In the Matter of)	
)	Docket 50-344
PORTLAND GENERAL ELECTRIC COMPANY,)	
et al)	(Control Building Proceeding)
)	
(Trojan Nuclear Plant))

I hereby certify that on July 10, 1979, Licensee's letter to the Director of Nuclear Reactor Regulation dated July 10, 1979 and an attachment entitled "Request for Additional Information, Trojan Nuclear Plant, Proposed Control Building Design", have been served upon the persons listed below by depositing copies thereof in the United States mail with proper postage affixed for first class mail.

Trojan Nuclear Plant
Docket 50-344
License NPF-1

Enclosed are the answers prepared by Bechtel Power Corporation to the remaining five questions from your letter of May 18, 1979. This submittal answers the last of the formal questions posed by your staff. A revision to PGE-1020 covering updated information will be issued shortly.

Figure 46- 20 Secant Modulus, Specimen L-2

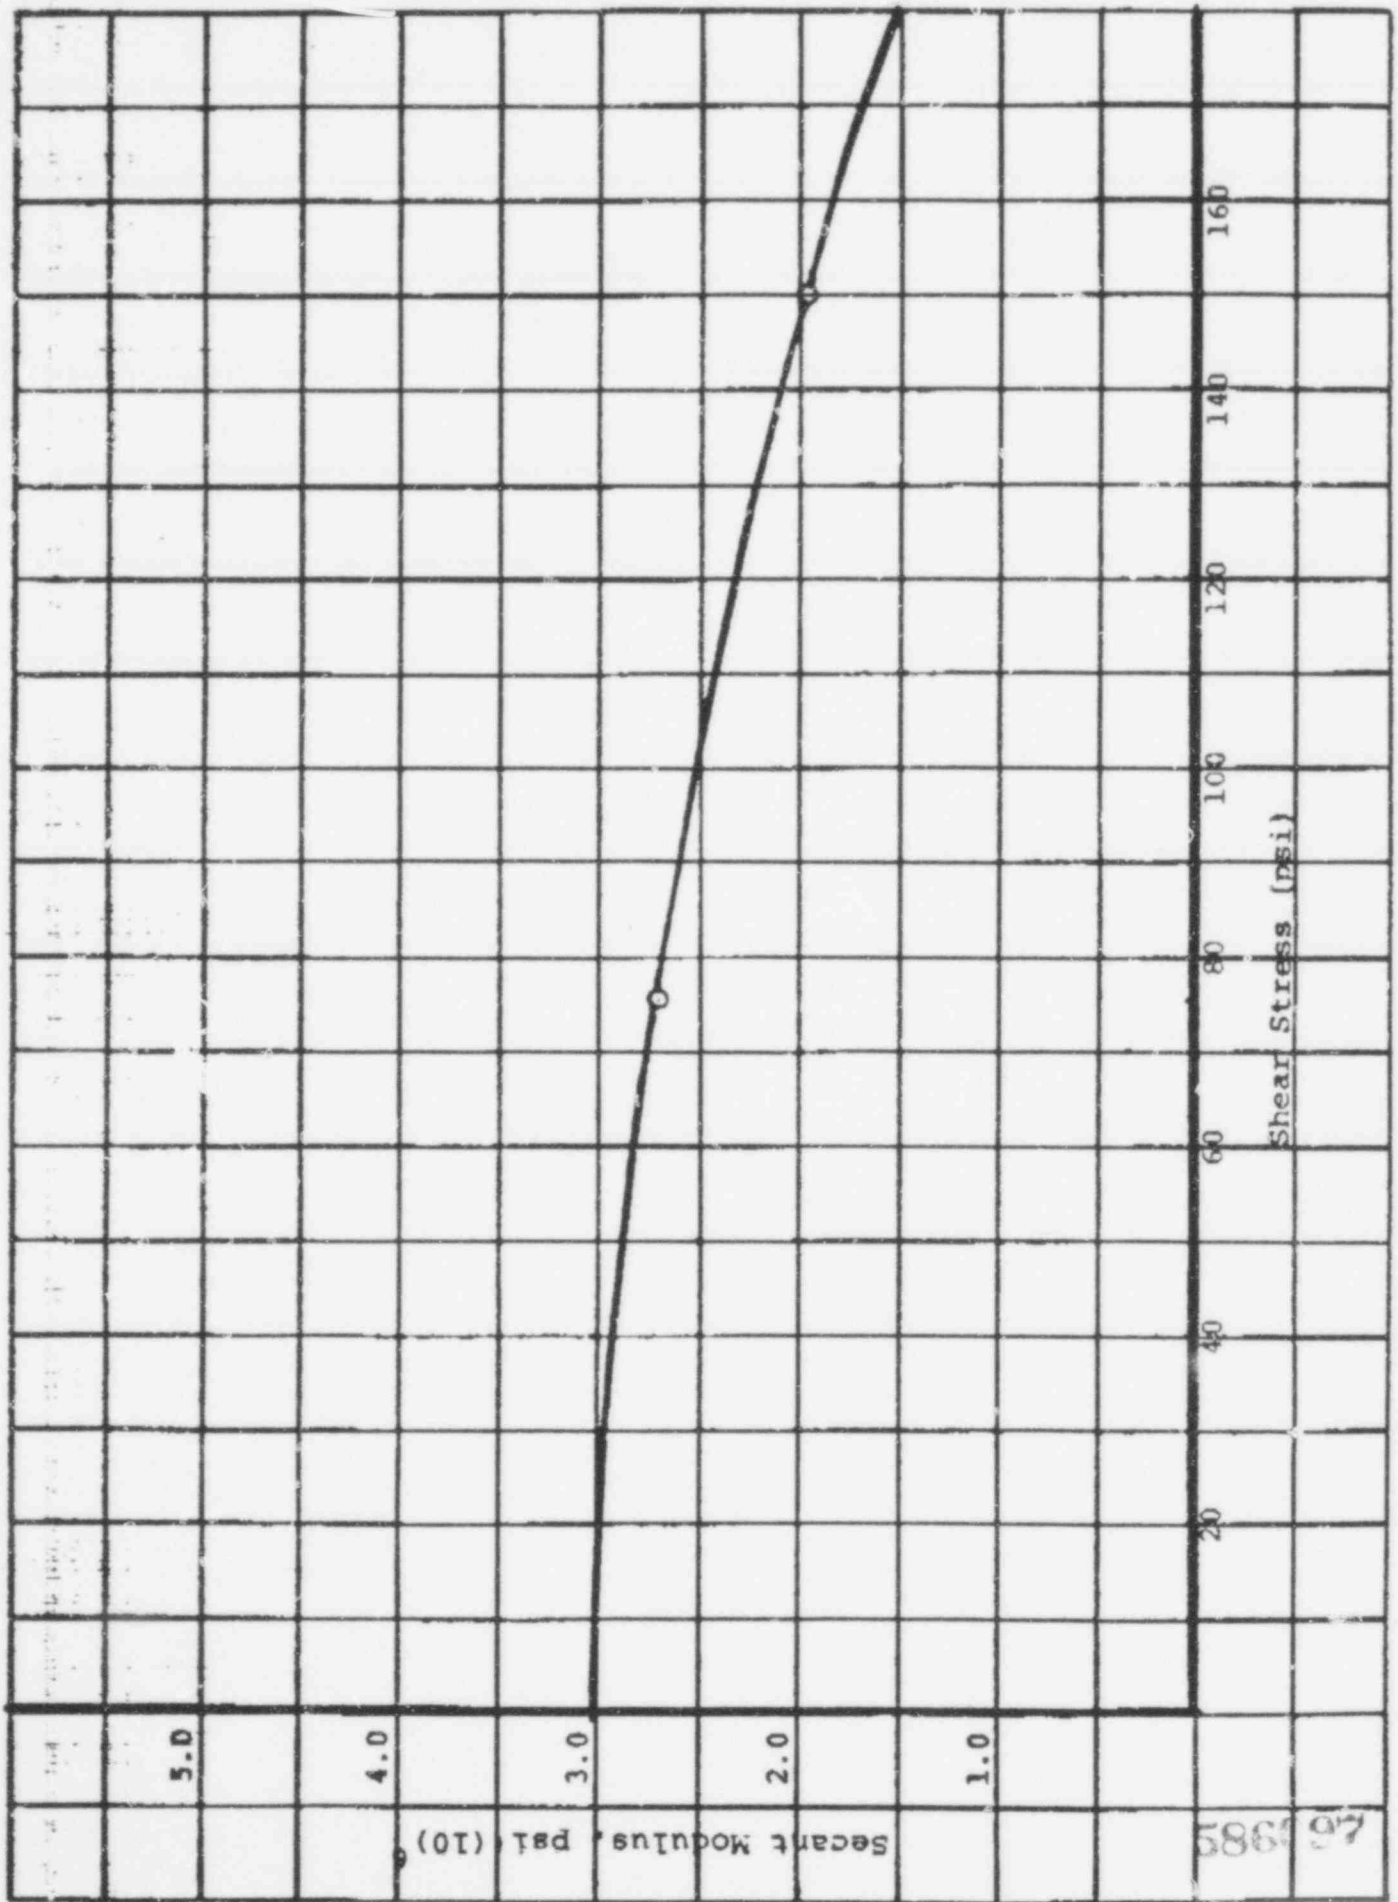
Provide the secant modulus derived for each of the test specimens vs. stress level; a comparison of the experimental initial elastic modulus for the test specimens vs. that calculated using the formula in Section 2.2.1.3.2 of Appendix B; the error bands, and their deviation, for the curves representing stiffness reduction as a function of stress level; and the stresses in each of the walls resulting from incorporation of the stiffness reduction factors in the STARDYNE model along with the associated stiffness reduction factors assumed in the analysis.

The secant modulus vs. shear stress for the test specimens is shown in Figures 46-1 through 46-20. A comparison between the experimental initial elastic modulus and that calculated using the formula in Section 2.2.1.3.2 of PGE-1020, Appendix B cannot be made since the initial modulus cannot be determined experimentally. The instrumentation was not sufficiently sensitive to measure the small deflections required for the calculation. Deflections need to be measured reliably to the nearest .0002 inch at the early stages of deformation. During this stage, the test specimen and load frame is settling in, play in instrumentation is being taken up, etc. Care was taken to minimize these effects but all could not be completely eliminated since the movements being considered are between 1 and 10 times smaller than the thickness of this paper. Some difficulty was even encountered at the first load step but for the other load steps the deflections were

large enough so that effects were not important. As shown in Figures 46-1 to 46-20, there are in general two data points at the first load step. The top part is obtained from the average deflections recorded on each side of the specimen and the other is obtained from the most active dial gauge. The initial modulus used in the plot was calculated using the equation in PGE-1020, Appendix B. An error analysis of the data could not be made since there are not enough specimens with duplicate conditions to provide sufficient data base. The effect of variation is considered in the broadening of the response spectra.
